Subject: Duke Energy Carolinas, LLC  
Oconee Nuclear Station (ONS), Units 1, 2, and 3  
Docket Numbers 50-269, 50-270, and 50-287  
License Amendment Request to Update Pressure-Temperature Limit Curves  
License Amendment Request (LAR) No. 2012-10

Subject: License Amendment Request to Update Pressure-Temperature Limit Curves  
License Amendment Request (LAR) No. 2012-10

**ATTACHMENT 1**  
**TECHNICAL SPECIFICATION**  
**MARK UPS**

Figure 3.4.3-4 (page 1 of 1)  
RCS Normal Operational Heatup Limitations  
Applicable for the First 33 EFPY - Oconee Nuclear Station Unit 2

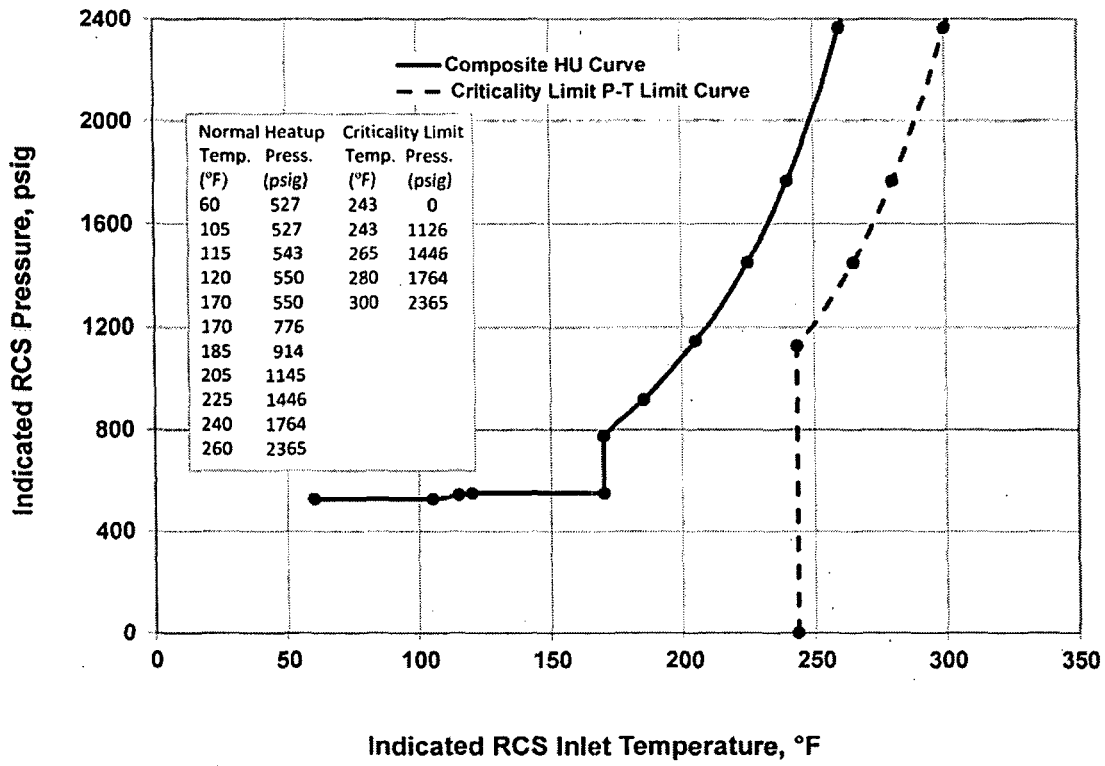
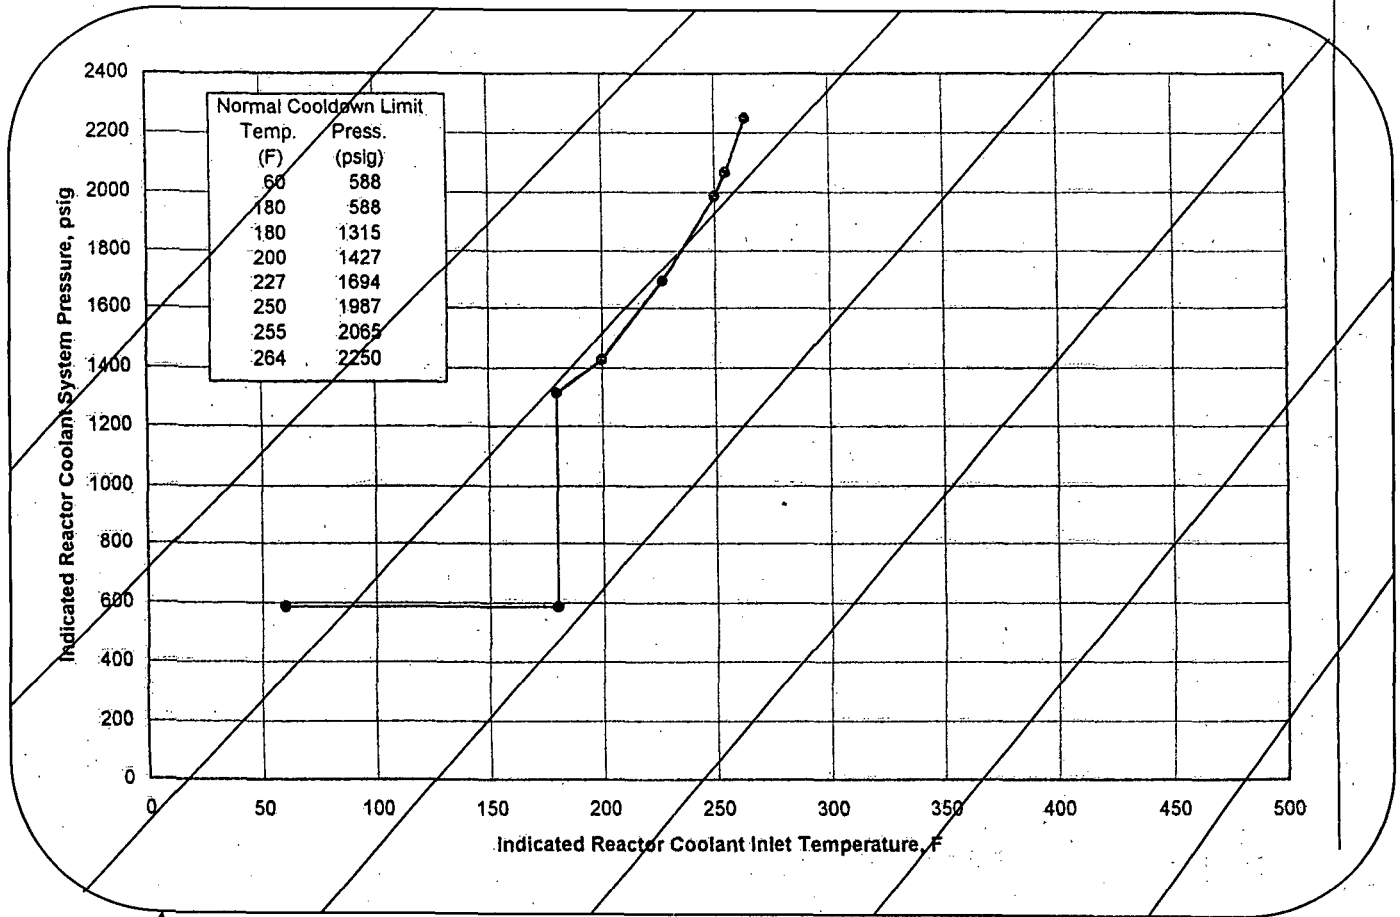
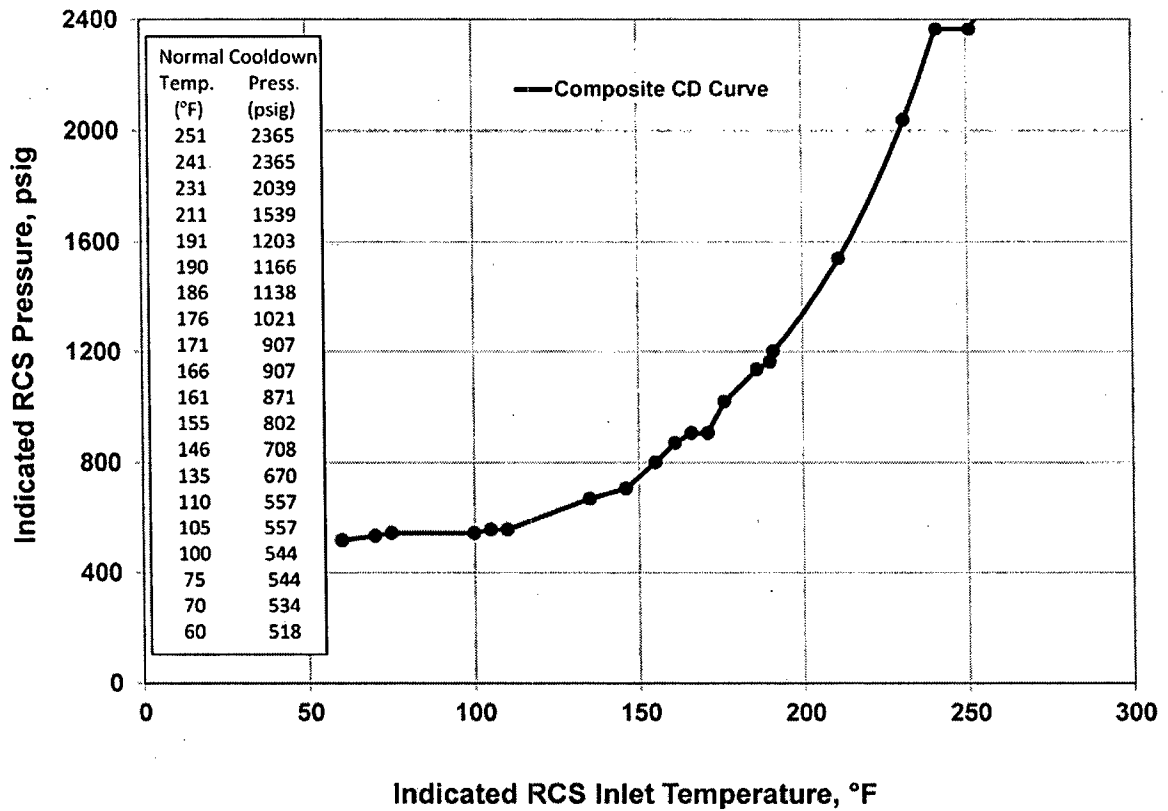
TS Limiting Condition for Operation (LCO) 3.4.3 currently provides the P-T limits for RCS Normal Operational Heatup Limitations, RCS Normal Operational Cooldown Limitations, and RCS Leak and Hydrostatic Test Heatup and Cooldown Limitations applicable to the first 33 EFPY in Figures 3.4.3-1, 3.4.3-2 & 3.4.3-3 respectively for ONS-1, in Figures 3.4.3-4, 3.4.3-5, & 3.4.3-6 respectively for ONS-2, and in Figures 3.4.3-7, 3.4.3-8, & 3.4.3-9 respectively for ONS-3. The proposed change would replace the existing P-T limits for 33 EFPY with P-T limits for 54 EFPY. Also, changes to the operational requirements for unit heatup and cooldown in TS Tables 3.4.3-1 and 3.4.3-2 are proposed. These changes are supported by the new 54 EFPY P-T limits. The proposed changes are depicted in the TS markup and retype provided in Attachments 1 and 2.

INSERT D

Figure 3.4.3-4 (page 1 of 1)  
RCS Normal Operational Heatup Limitations  
Applicable for the First 54 EFPY - Oconee Nuclear Station Unit 2

Figure 3.4.3-5 (page 1 of 1)  
RCS Normal Operational Cooldown Limitations  
Applicable for the First 33 EFY - Oconee Nuclear Station Unit 2

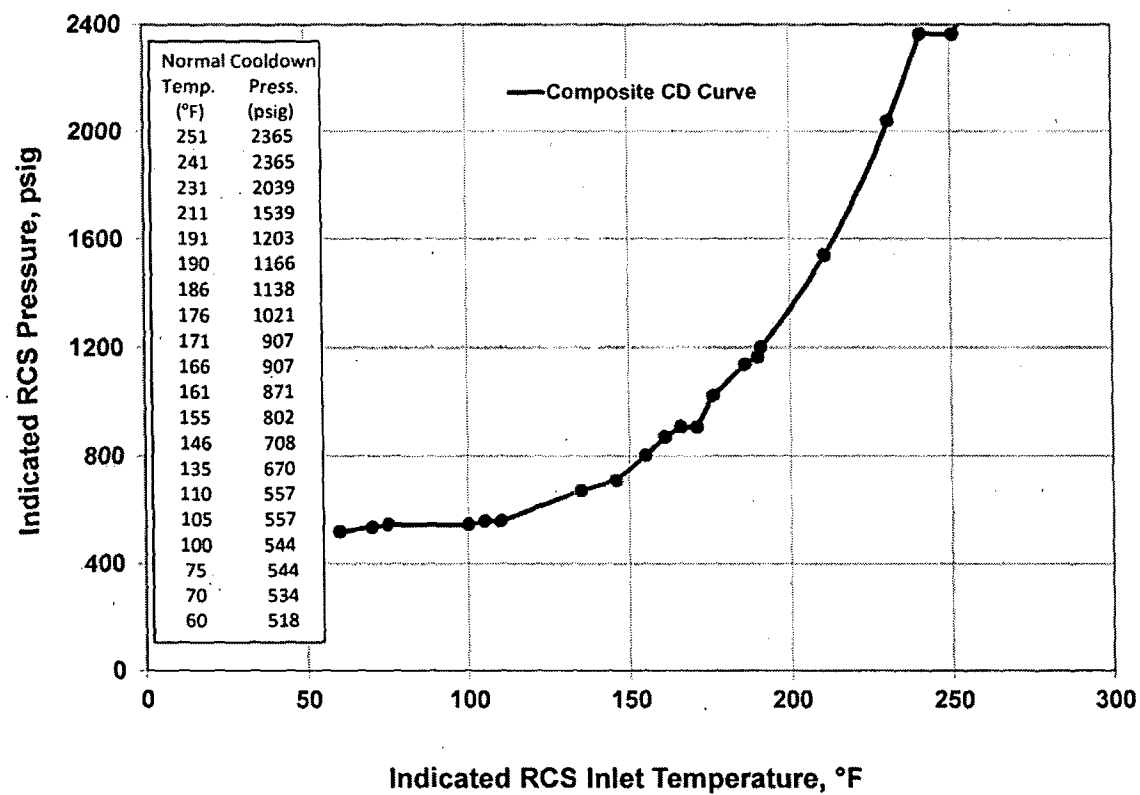
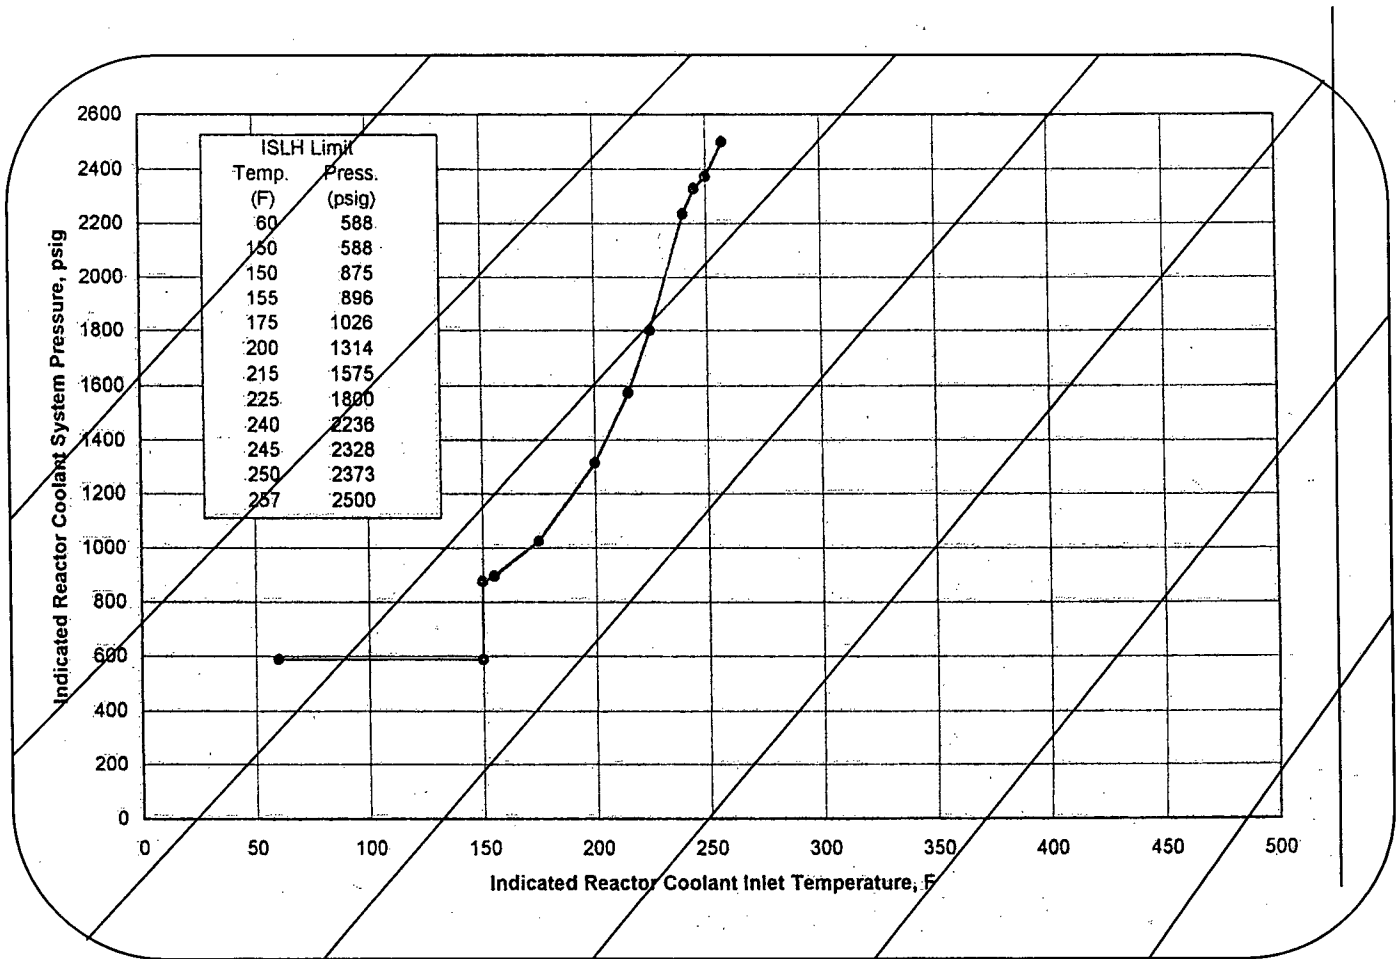
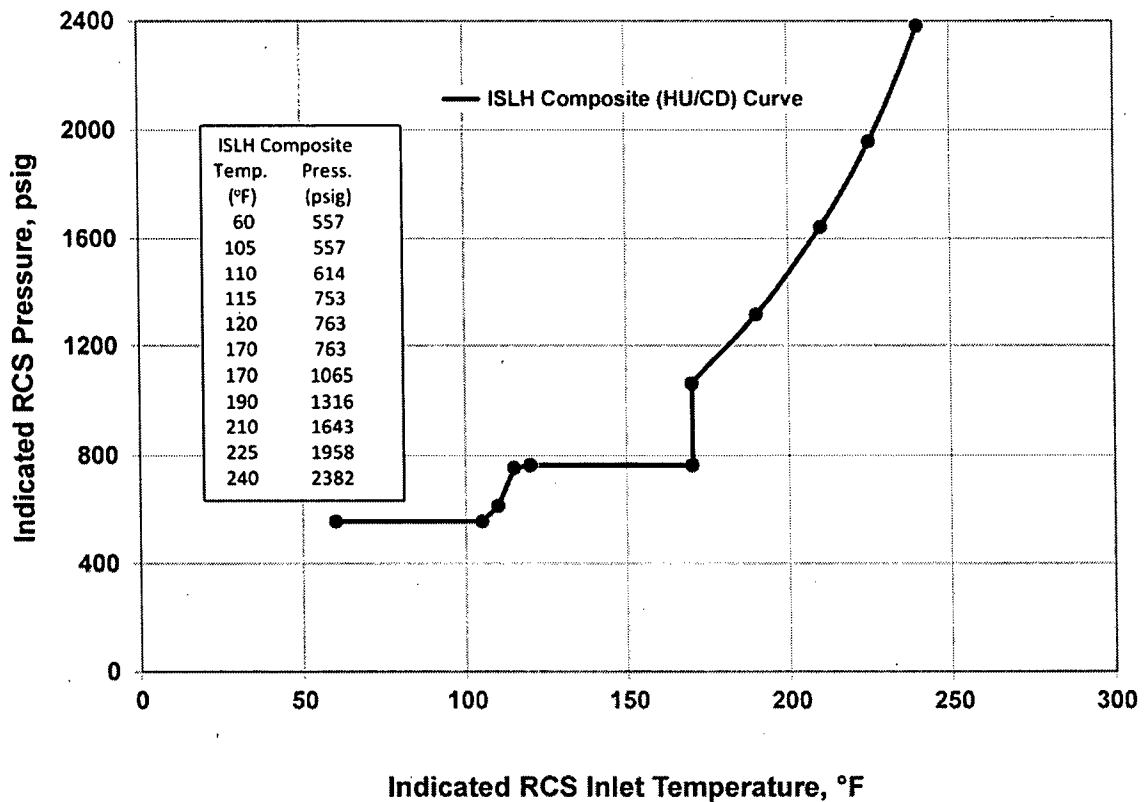
INSERT E

Figure 3.4.3-5 (page 1 of 1)  
RCS Normal Operational Cooldown Limitations  
Applicable for the First 54 EFPY - Oconee Nuclear Station Unit 2

Figure 3.4.3-6 (page 1 of 1)  
RCS Leak and Hydrostatic Test Heatup and Cooldown Limitations  
Applicable for the First 33 EFY - Oconee Nuclear Station Unit 2

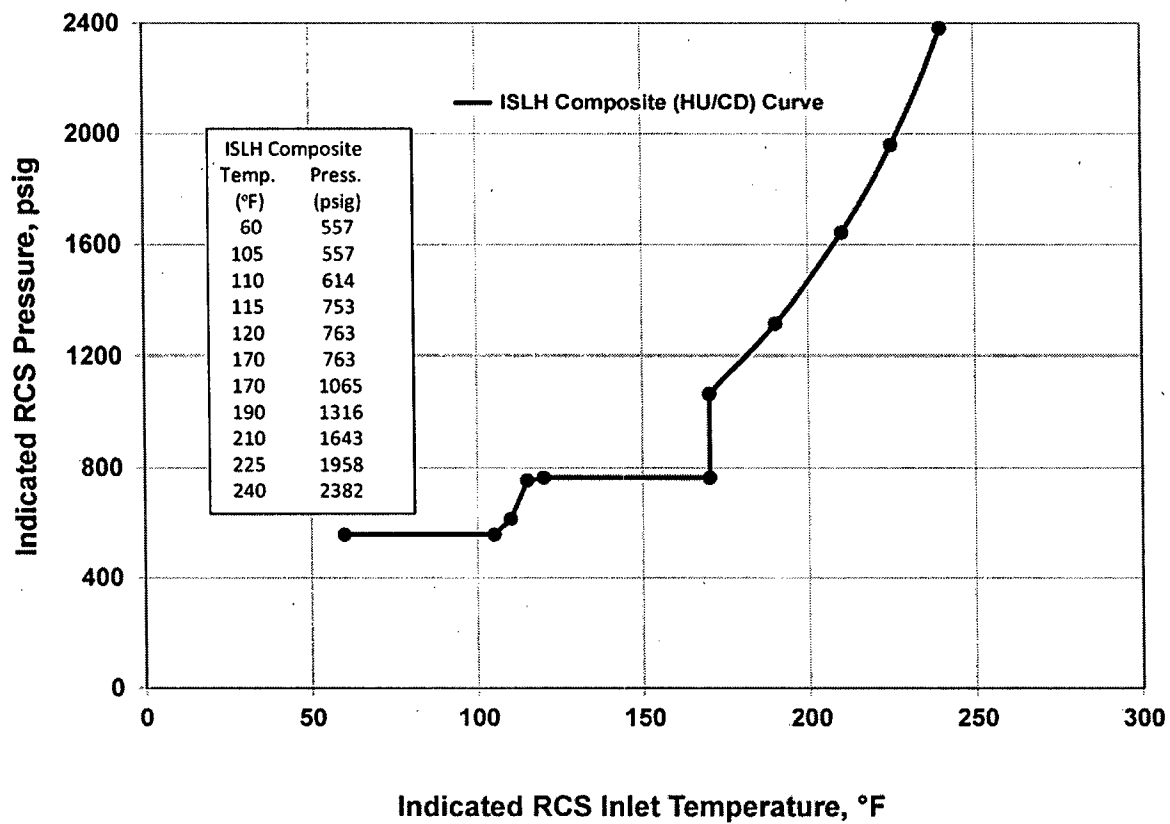
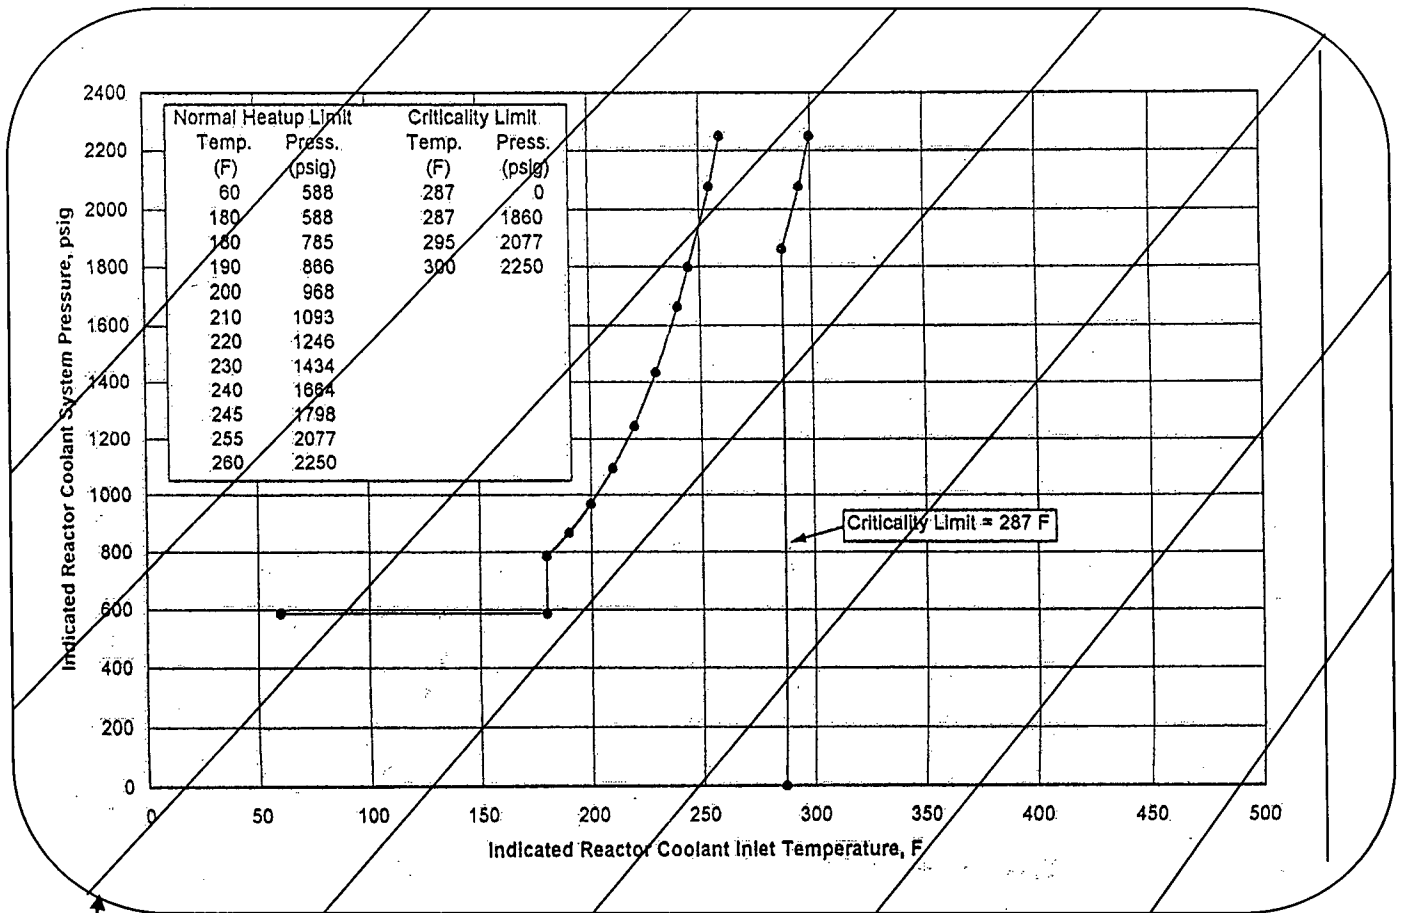
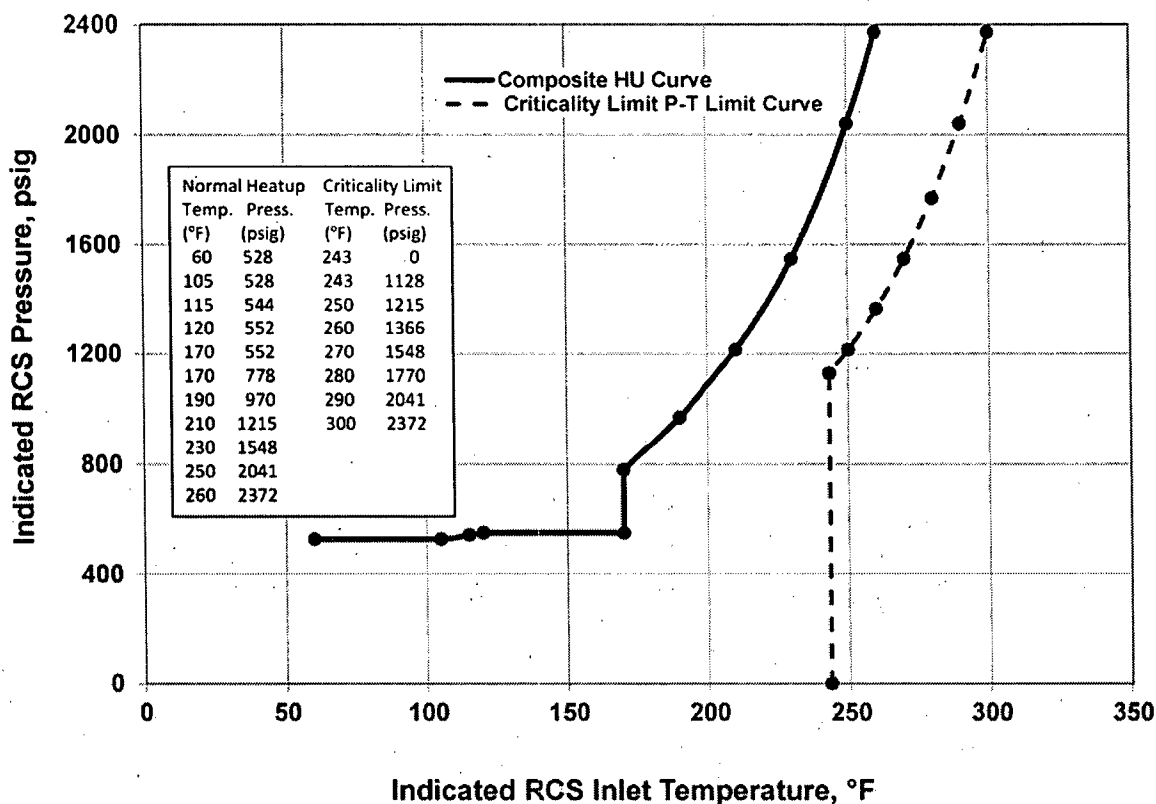
INSERT F

Figure 3.4.3-6 (page 1 of 1)  
RCS Leak and Hydrostatic Test Heatup and Cooldown Limitations  
Applicable for the First 54 EFPY - Oconee Nuclear Station Unit 2
